Sizewell C (SZC)

Planning Inspectorate Reference: *EN010012*

Deadline 3 – 24 June 2021

Comments on any additional submissions received at D2

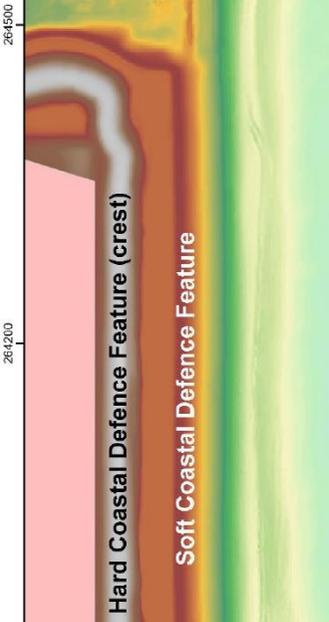
Pg. No.	Section Ref.	Relevant Text / illustration	Observations and Concerns	Requested:
9	ES	<i>The large SCDF volume, relatively low number of predicted recharge events and relatively small recharge volumes (based on very conservative measures) indicate that the SCDF is viable for at least the operation phase of the station.</i>	The SZC Co. position on viability should be clearly stated.	We request for SZC Co. to confirm that the site lifetime investment plan includes an allowance for all mitigation arising from the CPMMP including SCDF replenishment of the nature described but not limited to the frequency / volume stated in this report. If there is a limit on SZC Co. mitigation investment SZC Co. should declare now.
9	ES	<i>Longer timescales will be considered in future versions of this report, once modelling results are available.</i>	Covers the concern noted above.	
9	ES	<i>spatial patterns in erosion may trigger recharge in some areas (e.g., near the permanent Beach Landing Facility (BLF) where volumes are lowest) and not others.</i>	Will the monitoring plan be designed to cover these expected hotspots for depletion?	Confirm that the location of monitoring (RTK GPS) or remote sensing will include profiles from these erosion hot spots?

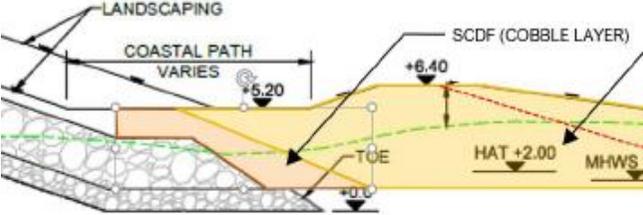
Pg. No.	Section Ref.	Relevant Text / illustration	Observations and Concerns	Requested:
9	ES	<i>The preliminary design presented will undergo further refinement including modelling to incorporate LST.</i>	Caveat noted	When is the refinement expected? Will it be submitted to PINS?
10	Fig 1	<i>HCDF / SCDF profile sac and buffer envelopes shown.</i>	There is no consideration in report of SCDF viability with adapted HCDF profile.	Include a Section in the report (or TR545) for design and viability of SCDF fronting adapted profile.
10	Fig 1	<i>HCDF / SCDF profile sac and buffer envelopes shown.</i>	Two points in relation to “landscaping”: <ul style="list-style-type: none"> • The coastal path runs beneath the landscaping. • The landscaping runs over the crest at a thickness of 2m or 2.9m if the unlabelled layer beneath it is also landscaping. If not removed before the HCDF becomes an active defence, this material could seriously affect the hydraulic performance of the HCDF (run up and overtopping). 	Clarification on the location of the landscaping in relation to the coastal path. Further information regarding long term future management of the landscaping layer.

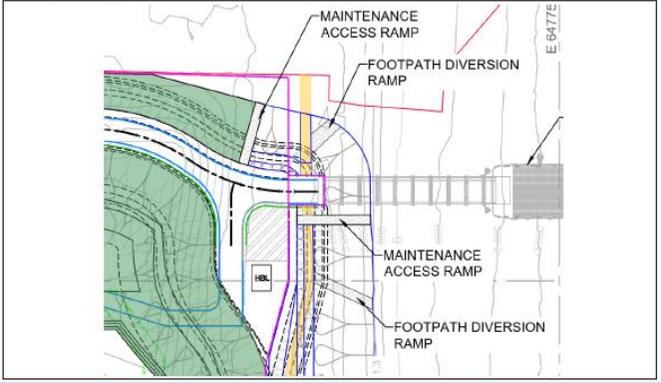
Climate Change/ Timescale	Design Cases (Design Basis)	Design Case: Cliff Edge (Beyond Design Basis)	Reasonably Foreseeable (RF) 2110-2140	1 in 10,000 year return period storm event (95%ile) UKCP18, RCP8.5 – 95%ile SLR Long-term coastal erosion of 0 – 20m Hydraulic roughness 0.5 Storminess Wave Height Increase 10% Existing protection from offshore banks	1 in 100,000 year return period storm event (50%ile) UKCP18, RCP8.5 – 95%ile SLR Long-term coastal erosion of 0 – 20m Hydraulic roughness 0.5 Storminess Wave Height Increase 10% Existing protection from offshore banks	Credible Maximum (CM) 2110 -2140	1 in 10,000 year return period storm event (95%ile) H++ sea level rise – BECC Upper Long-term coastal erosion of 20m to 40m Hydraulic roughness 0.5 Storminess Wave Height Increase 10%	1 in 100,000 year return period storm event (50%ile) H++ sea level rise – BECC Upper Long-term coastal erosion of 20m to 40m Hydraulic roughness 0.5 Storminess Wave Height Increase 10% Offshore banks lowered in height	<p><i>In all cases given, Hydraulic Roughness is given as 0.5. Advise definition of Hydraulic Roughness (of sea bed, of revetment slope, proxy factor for run up/overtopping ...?)</i></p>	<p>Further information sought on the Hydraulic roughness parameter (stated dimensionless 0.5).</p>
Climate Change/ Timescale	Design Cases (Design Basis)	Design Case: Cliff Edge (Beyond Design Basis)											
Reasonably Foreseeable (RF) 2110-2140	1 in 10,000 year return period storm event (95%ile) UKCP18, RCP8.5 – 95%ile SLR Long-term coastal erosion of 0 – 20m Hydraulic roughness 0.5 Storminess Wave Height Increase 10% Existing protection from offshore banks	1 in 100,000 year return period storm event (50%ile) UKCP18, RCP8.5 – 95%ile SLR Long-term coastal erosion of 0 – 20m Hydraulic roughness 0.5 Storminess Wave Height Increase 10% Existing protection from offshore banks											
Credible Maximum (CM) 2110 -2140	1 in 10,000 year return period storm event (95%ile) H++ sea level rise – BECC Upper Long-term coastal erosion of 20m to 40m Hydraulic roughness 0.5 Storminess Wave Height Increase 10%	1 in 100,000 year return period storm event (50%ile) H++ sea level rise – BECC Upper Long-term coastal erosion of 20m to 40m Hydraulic roughness 0.5 Storminess Wave Height Increase 10% Offshore banks lowered in height											
12	3.4.1	<p><i>The HCDF comprises a rock revetment with a double armour layer of 6 to 10 tonne quarried armour stone rock over a rock underlayer, granular core and ground improvements (where needed).</i></p>	<p>Layer thicknesses based on this grading are: Mean 8 tn rock has Dn50 of ~1.45m. 2 layer thickness = 1.8 * 1.45 = 2.6m plus underlayer of ~ 1m?. Total thickness 3.6m? Looks like ~ 4m ODN on profile.</p>	<p>Confirm that the upper surface of the rock layer at the HCDF toe is at 4m ODN that is ~1m below the existing 5m berm and above the level of the shingle back beach landward of the berm.</p>									
12	Table 3-2	<p>Re armour size: <i>A concrete armour solution is frequently considered when a larger rock size is required. A concrete armour solution is not required for the HCDF but may be required for the Adaptive Design.</i></p>	<p>This is not very informative. Please provide the rationale for selecting very large rock armour over concrete armour units in this case. Generally, concrete armour units can be placed to a steeper slope than rock, thus reducing footprint (in fact the steeper slope can be preferred to obtain higher friction forces between units). It is understood that a higher crest may be required to obtain the target overtopping limit. However, we would like to see that this topic has been assessed and the</p>	<p>Further information is required as explained in the comment box to the left.</p>

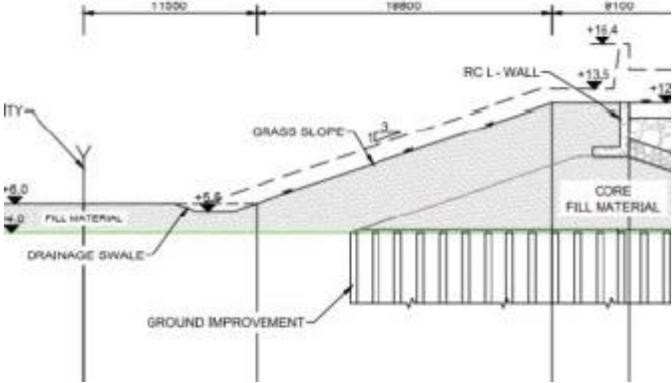
<p>Figure 3-6 - SZB Interface - Plan</p>		
Pg. No.	Section Ref.	Relevant Text / illustration	Observations and Concerns	Requested:
14	3.5.2	<p><i>Landscaping material placed above the functional crest level of +12.6mOD is not considered to contribute to the claimed performance of the HCDF. However, it is recognised that the presence of this material will in practice provide some beneficial effect</i></p>	<p>The statement is almost implying that the landscaping material will be detrimental to performance of the HCDF, without saying as much.</p>	<p>This is the same argument as noted re p3 Fig. 3.3. Clarification is needed on the performance/impact of landscaping, demonstrating definitively that there will be no additional incursion of the HCDF into the coastal regime as a result of it.</p>
15	3.6	<p><i>Drainage Swale</i></p>
